TECHNICAL ASSISTANCE WORKSHOP
FOR THE WORLD HERITAGE SITES OF
THE CRAC DES CHEVALIERS, PALMYRA
AND THE ANCIENT CITY OF DAMASCUS
Beirut 13, 14, 15 December 2016

ANCIENT CITY OF DAMASCUS
Building of the Ottoman Bank

Review of the restoration project prepared by the Directorate of the Old City of Damascus

Project for the rebuilding of the superstructures

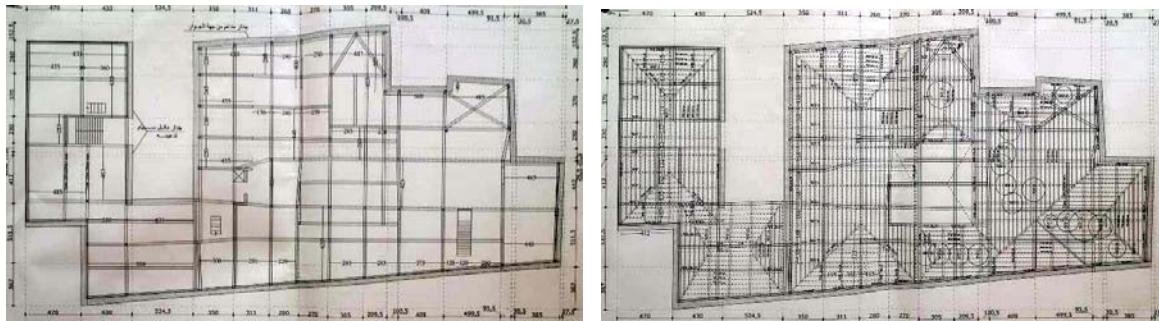
The structural project proposed has raised the following observations and criticisms from the engineer Salvatore Russo:

The building shows structural problems due to the damages of fire on the bearing mortar-brick walls of the building. The fire destroyed the wooden roof structure, which collapsed.

The status of the structural damage caused by the fire needs to be carefully considered, in particular load bearing outer walls and the iron beams that support the floor between the ground floor and the first floor.

From a general point of view, the project proposed is incomplete as it lacks adequate structural transversal and longitudinal sections in order to clearly understand the design process.

The project presented for the potential recovery of the building appears insufficient from the point of view of the structural choices taken and of the structural consolidation proposed. Moreover, a careful analysis of the structural damage fire on structures caused by the fire is mission as well as the resulting decisions to be taken in relation to structures.

The additional masonry partitioning the first floor were built as non-load-bearing walls. In the project, their use is "diverted" in order to give them a structural role in replacement of the old inner framework of pillars destroyed by fire. Thus, the weight is transferred on the superstructures of the upper flooring of the ground floor, possibly already weakened by the fire and whose residual strength has not been verified.

Moreover, this solution presents a major limitation in terms of future use: endorsing a recent, purely utilitarian partitioning would definitively jeopardize any future possibility to re-establish the large volumes at the first floor. It will jeopardize the feasibility to develop valorisation programmes in the future, such as a touristic, cultural or social programme. Such programme would be most welcomed in this historic space, located in a privileged sector and in the immediate vicinity of the citadel and several historical monuments of great interest (such as the Koranic schools of the

- Abandon the construction principle currently proposed (i.e. to use the recent partitioning walls at the 1st floor to support a framework of metal profiles, itself supporting in an undifferentiated way the various roofing frameworks) and favour an independent structure of pillars implanted at the same locations as those of origin and, in particular, at the corners of the different pavilions,

- If necessary, reduce the facades of the excesses of load that they would no longer be able to support, and implement, at their back, a secondary structure able to support the load,

CROSS SECTION: P.A. Lablaude 27/12/2016

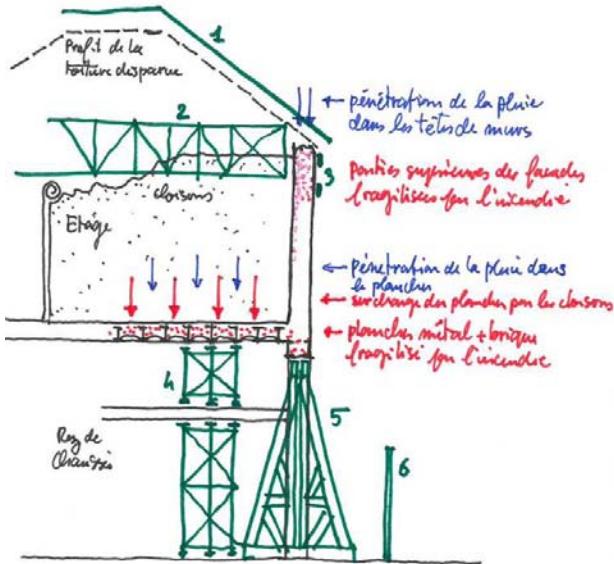
7. **Implement the urgent security and stabilization measures:** The fire has severely weakened the building, which is currently directly exposed to weathering, due to the destruction of the roofs. The remains of the building are exposed to a rapid deterioration, and its instability is a serious threat for its direct environment (falling parts or partial collapses).

Therefore, it is recommended to install urgently a protective umbrella over the building in order to ensure the complete protection from weathering of the remains, especially the upper parts of the façades and the upper flooring of the ground floor.

Such covering can be realized with the materials available in the market and without loading the damaged structures. If the walls will support the covering, they should be shored up first with a spatial "St. Andrew's cross" wooden shoring system in order to passively support of all walls. The shoring of the floors damaged by fire will be also realized with a passive double FRP band belting all the affected perimeter masonry walls.

In addition, if the studies previously recommended confirm a clear damage by the fire of the mixed structure (metal and brick) located at the upper flooring of the ground floor, it would also be necessary to plan a shoring system for the destabilized areas.

- 1: Umbrella protecting the building from weathering
- 2: Supporting structure of the umbrella potentially acting for the triangulation of the façades
- 3: Double belting of facade walls
- 4: Inside shoring of the upper flooring of the ground floor
- 5: Shoring and triangulation of the various openings in the façades
- 6: implementation of a security fence on the street to ensure the public safety (risk of material falling)

The present sketch is provided solely for guidance and must be confirmed by a precise diagnosis to be carried out on the spot. A proper detailed project for the shoring and protection of the building which takes into account its different constraints (loads, overloads, wind forces, etc.) should be analysed at a later stage,
